Application Type: **Site Plan**
 Status: **First Referral**
 Application Name: **Parker and Pine F1 L6 – Everbrook Daycare**
 Case/AP#: **SP20-058**
 Referral Received: January 29, 2021
 Comments Due: February 23, 2021

TOWN OF PARKER FIRE/LIFE SAFETY:	R REVIEWED FOR CODE COMPLIANCE; REVISIONS REQUIRED
---	---

- 1st Submittal – Reviewed February 16, 2021
- 2nd Submittal – Reviewed May 21, 2021 (*comments in red, italicized font*)

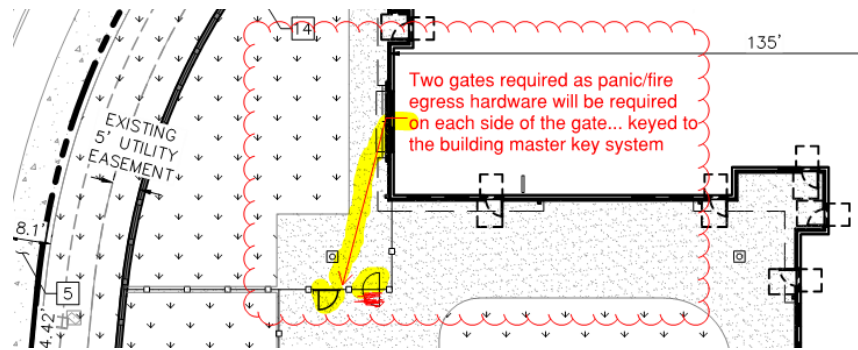
- A. *Please provide information as to what these symbols are on the site plan; should these be bollards and a fence, the improvements should be inset to allow vehicles to fully use the parking spots. Should there be a fence in this location, the question arises as to how parents and children will access the walkway without having to walk through a parking lot. Additionally, emergency access will be compromised should a fence be installed in this area. See below and address this issue when resubmitting:*

What are these symbols? Provide information on this.

Callout (19) has been added to clarify. These are proposed bollards. No fence will be added. Bollards have been shifted to be in sidewalk.

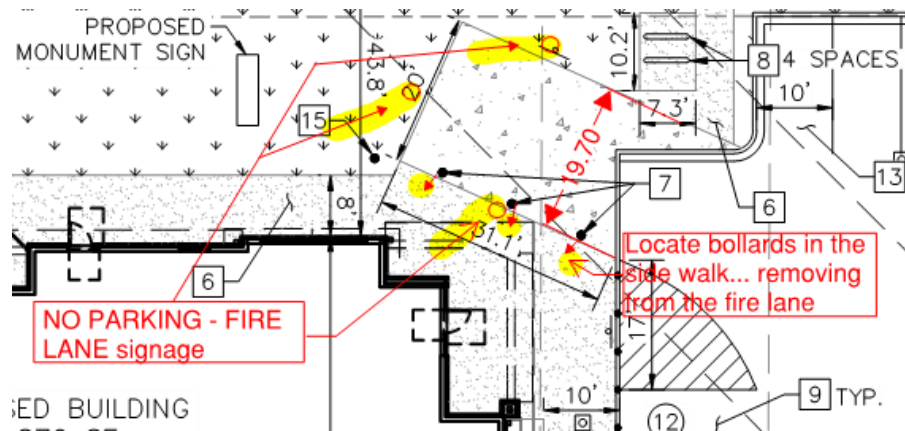
11. The construction drawings indicate that there are three proposed removable bollards to be placed at the hammer head required for site access; the applicant shall remove the bollards from the site plan as they are not allowed. Signage maybe placed that states EMERGENCY ACCESS ONLY on each side of the entry. No Parking – Fire Lane signage (with directional arrows pointing either direction) shall be placed on all three sides of the hammerhead. See below for fire lane signage areas. *Partially satisfied; applicant has relocated the “removable” bollards though and placed adjacent to the access (Bldg side). The bollards, however, are shown in the 20-foot clear width of the required fire lane and shall be placed in the sidewalk outside of the 20-foot clear width requirement. See below for more direction and address this issue when resubmitting.*

Bollards have been updated to show outside of the 20' clear area.
